# Work Order ID 80133

Item Name: Crosstube Turning Detail

<b>DART AEROSPACE LTD</b>	<b>Work Order:</b> 80133
<b>Description:</b> Crosstube Assembly (412 High Aft)	<b>Part Number:</b> D412-664-243
<b>Inspection Dwg:</b> D412-664-243 Rev: E	<b>Page 1 of 1</b>

DRAWING NO. D412-664-243	TITLE CROSSTUBE ASSEMBLY (412 HI AFT)	REV. E	DART AEROSPACE LTD ENGINEERING ORDER		D.E.O. NO. D412-664-243-E-1	SHEET NO. SHEET 1 OF 2	SCALE NTS
DRAWN	CHECKED <i>MP</i>	MFG. APPR. <i>E</i>	APPROVED <i>MP</i>	DE APPR. <i>MP</i>			
DATE 11.03.31	DATE 11/03.31	DATE 11.03.31	DATE 11/03.31	DATE 11.03.31

**D412-664-243**  
**ASSEMBLY DETAIL**

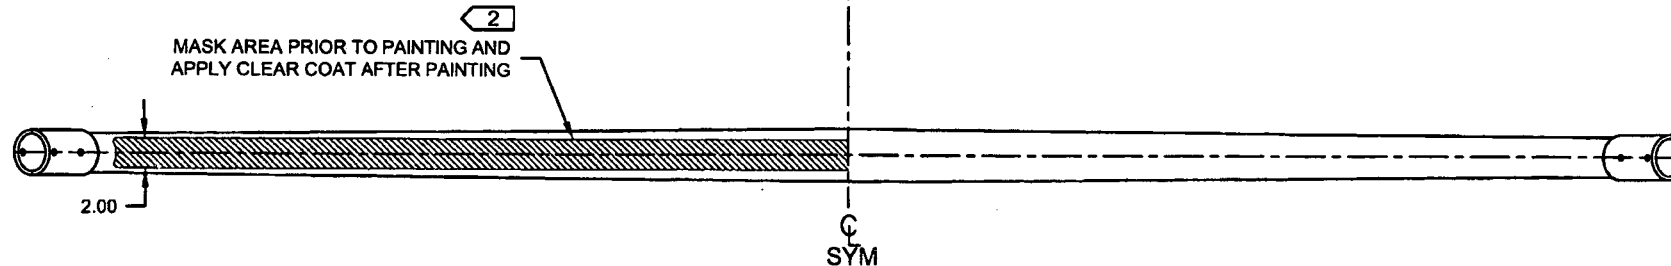
**PURPOSE:**

REMOVED ABRASION STRIP IN FAVOR OF A THIN LAYER OF PROSEAL 890.

**IS:**

D3189-1 CHAFING SHIELD (1, INSTALLED OVER PROSEAL 890)  
MS21920-28 CLAMP, 2X  
2 PL

**WAS:**

D2856-600-1009 ABRASION STRIP  
D3189-1 CHAFING SHIELD (1, INSTALLED OVER ABRASION STRIP)  
MS21920-28 CLAMP, 2X  
2 PL
